HERBATA DATA CENTRE, NAAS - RESPONSE TO REQUEST FOR FURTHER INFORMATION ("RESPONSE TO RFI") FROM KILDARE COUNTY COUNCIL

ADDENDUM TO CHAPTER 12 TRAFFIC AND TRANSPORTATION

NI2615
01
June 2025

Figure 12.1: Detail of Proposed R409 Improvements (extract of now submitted drawing 2232-DOB-ZZ-ZZ-DR-C-1600)

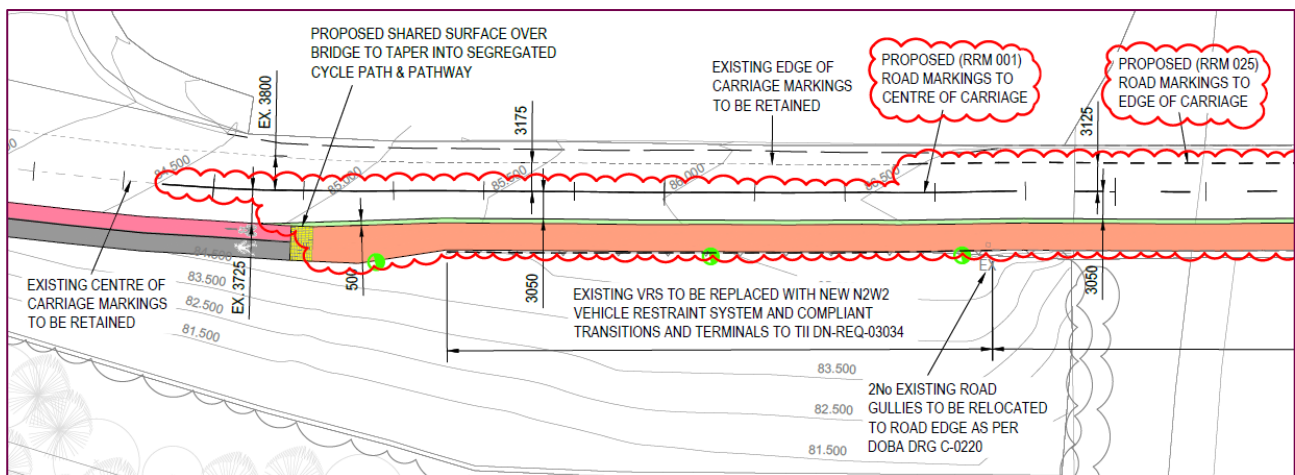
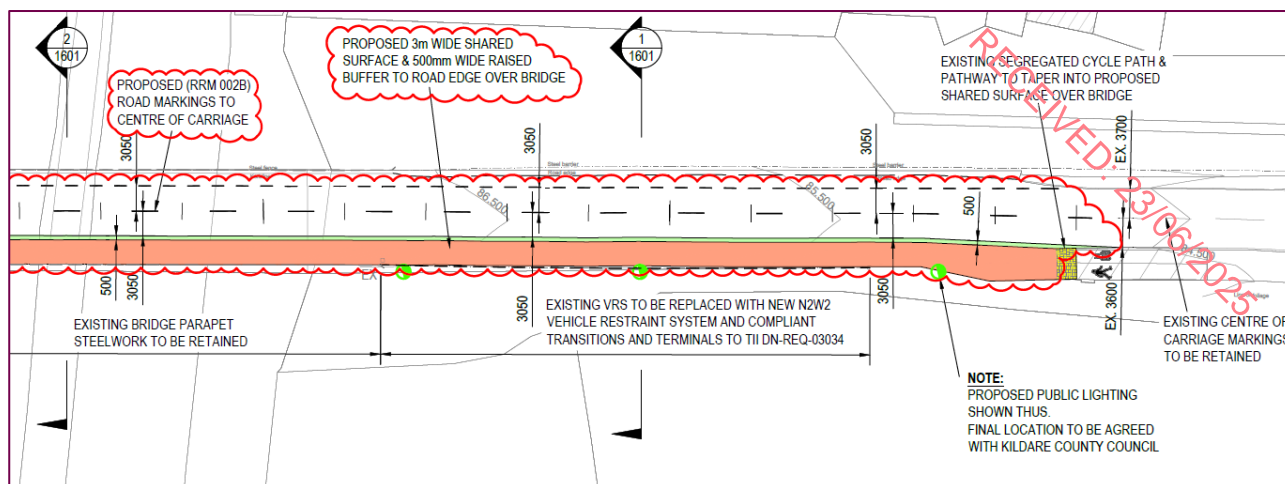
The amendments propose a footpath and associated line markings, and replacement of the traffic barriers, which will be undertaken on the R409 (where it crosses over the M7 motorway) and are detailed in Figures 12.1 and 12.2 (extracts from drawing 2232-DOB-ZZ-ZZ-DR-C-1600 PROPOSED R409 ROAD VRU IMPROVEMENTS).

In summary, the proposed amendments comprise of the provision of a 3m shared surface (with a 500mm buffer) across the bridge and a reduction in the carriageway width from 7.8m to 6.1m, across the bridge; by comparison, the submitted application proposed a 2m shared surface (with no buffer).

Figure 12.3: Proposed HGV Route from Dublin Port to Site on National Motorway Road Network (extract from updated CTMP, Volume II, Appendix 4.6)

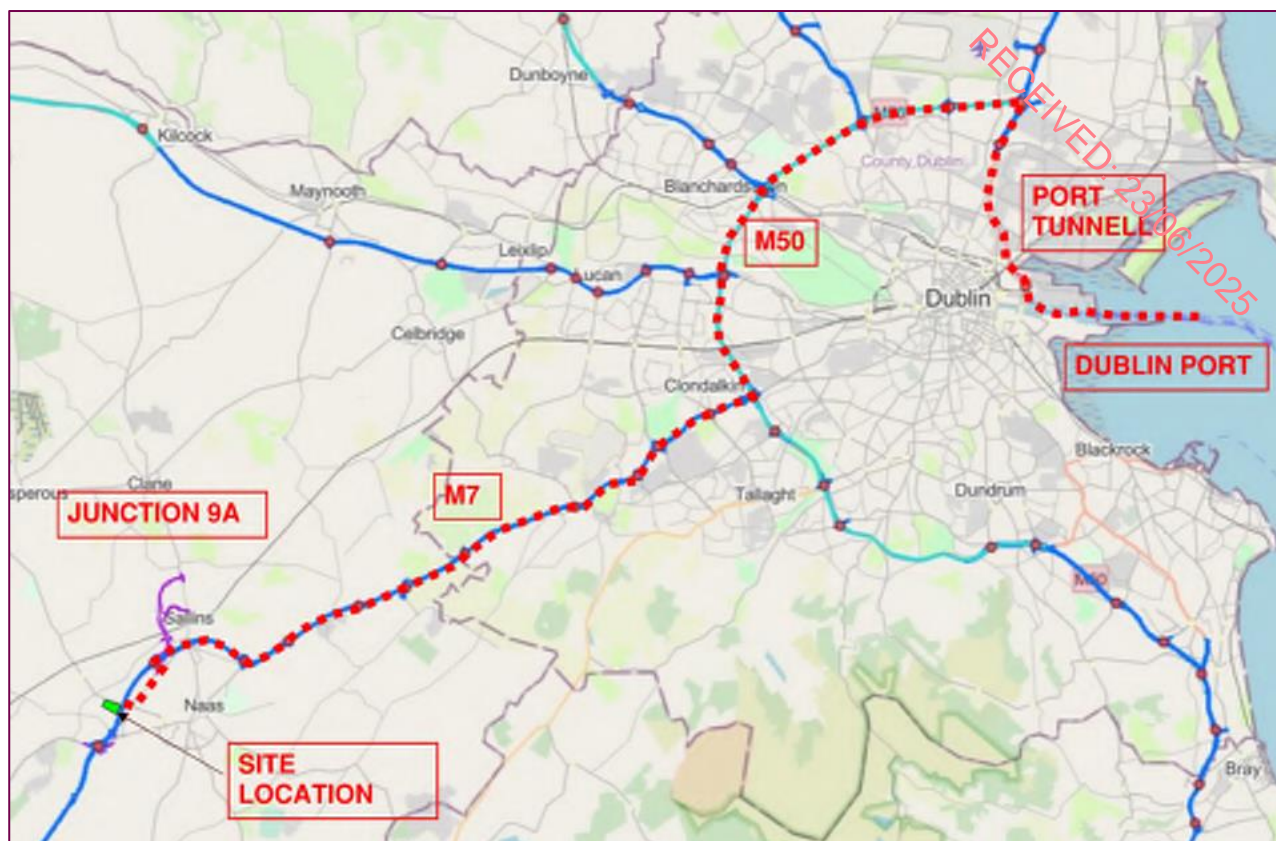
Dublin Port has been identified as the closest port to the Project and is the port through which imported specialised equipment (turbines and substation components) will be delivered. Figure 12.3 illustrates the proposed route of HGV vehicles transporting imported equipment to the site during the construction phase via the National Motorway Network.
